Project: Iowa Army Ammunition Plant  
Equipment: EM-61 (1.0x0.5m)  
Grid/Location: GPO

## URS RESPONSE TO USEPA AND US ARMY COMMENTS

### DRAFT GPO TECHNICAL MEMORANDUM MILITARY MUNITIONS RESPONSE PROGRAM AT IOWA ARMY AMMUNITION PLANT

Figure E-6 Approved: \_\_\_\_\_

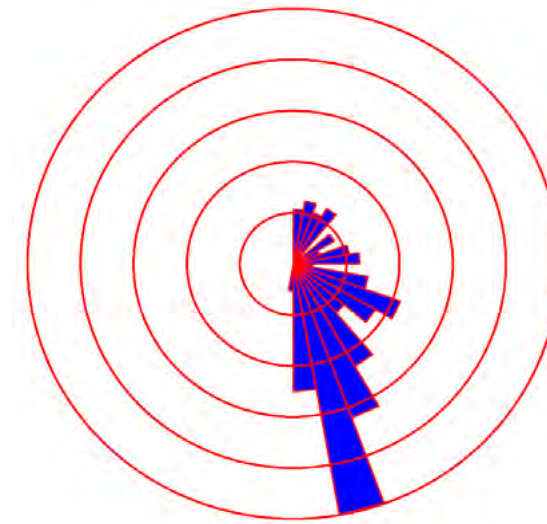
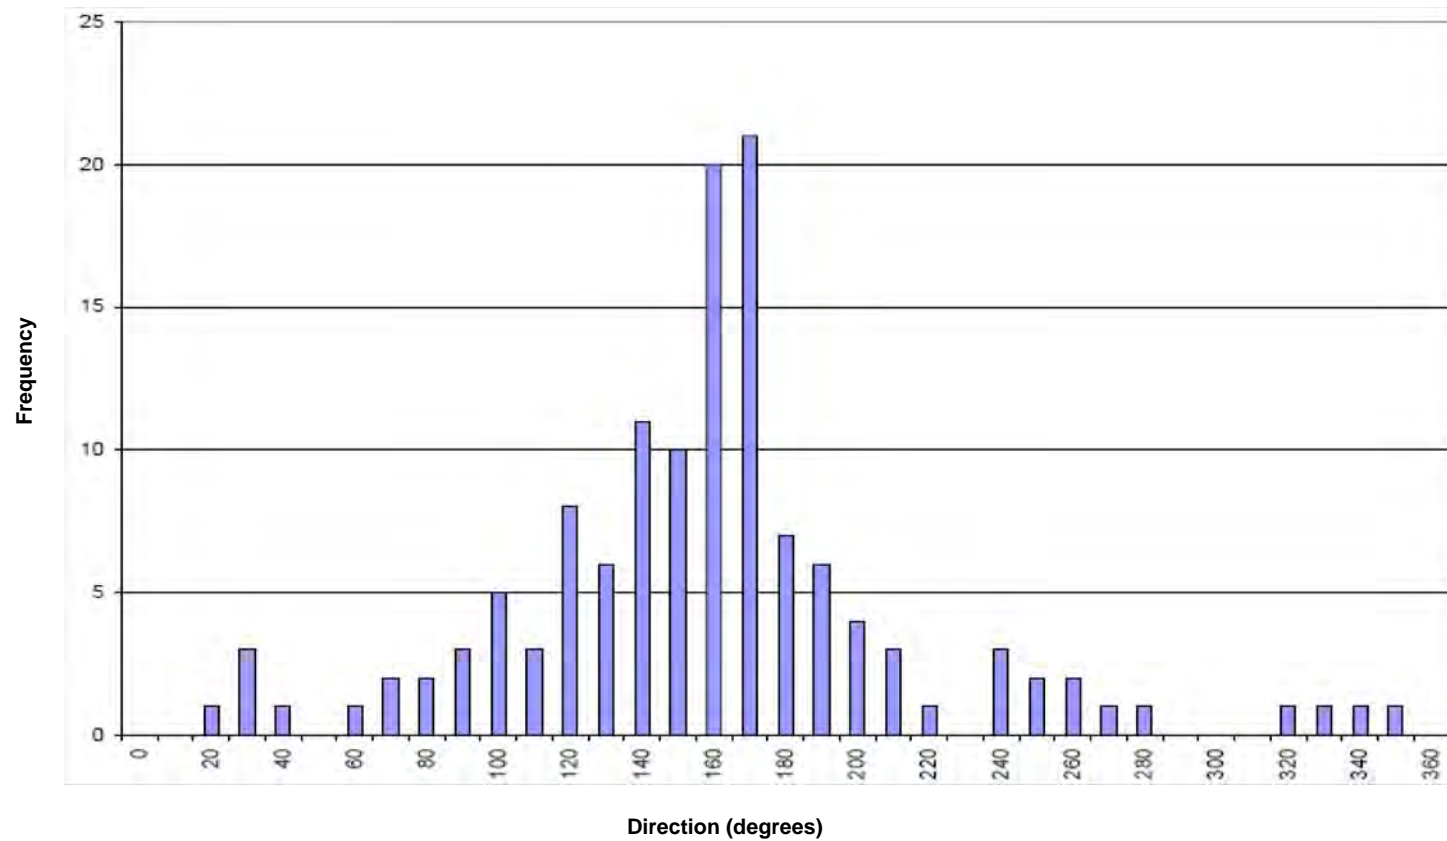
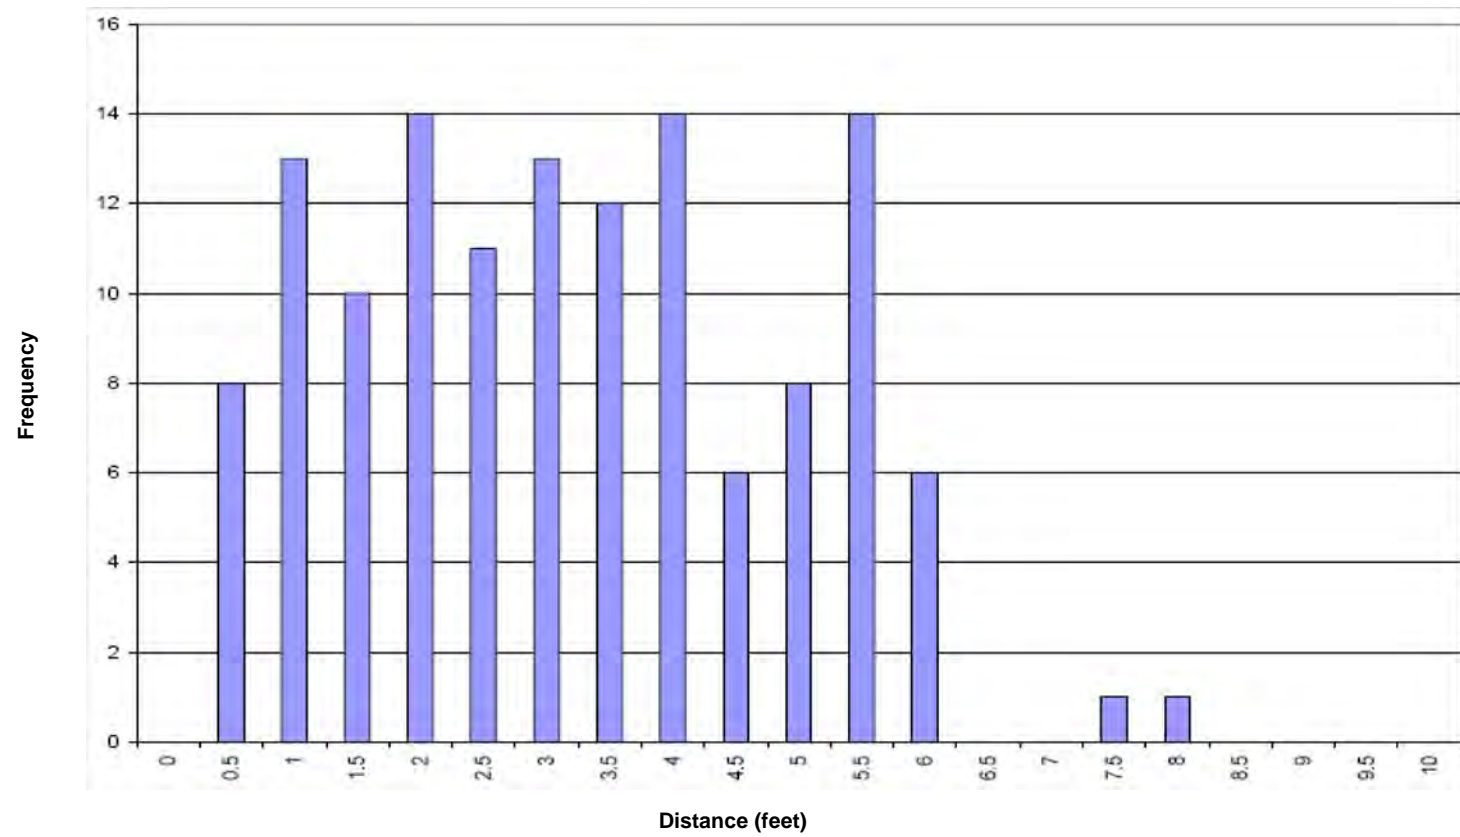
**Comment 28.** Section 5, Page 5-1, Reacquisition Results, paragraph 3 - The positional shift looks like it would work well at the Central Test Area, where a normal distribution can be seen in Figure E-3, but Figure E-6 shows a different story for the Line 6 Ammo Production MRS. Assuming Figure E-6 shows locations that have not been adjusted 5 feet, 53% would still lie outside of the 1-meter radius if adjusted by 5 feet. Please discuss.

**Response:** Agree. See response to Comment number 3. If one assumes that the MKM base station remained at the same location for the duration of data acquisition, the offset distance and direction should be similar for Line 6 and the CTA. It is possible that the density of anomalies located within Line 6 may have attributed to locating a target not associated with the selected/intended target
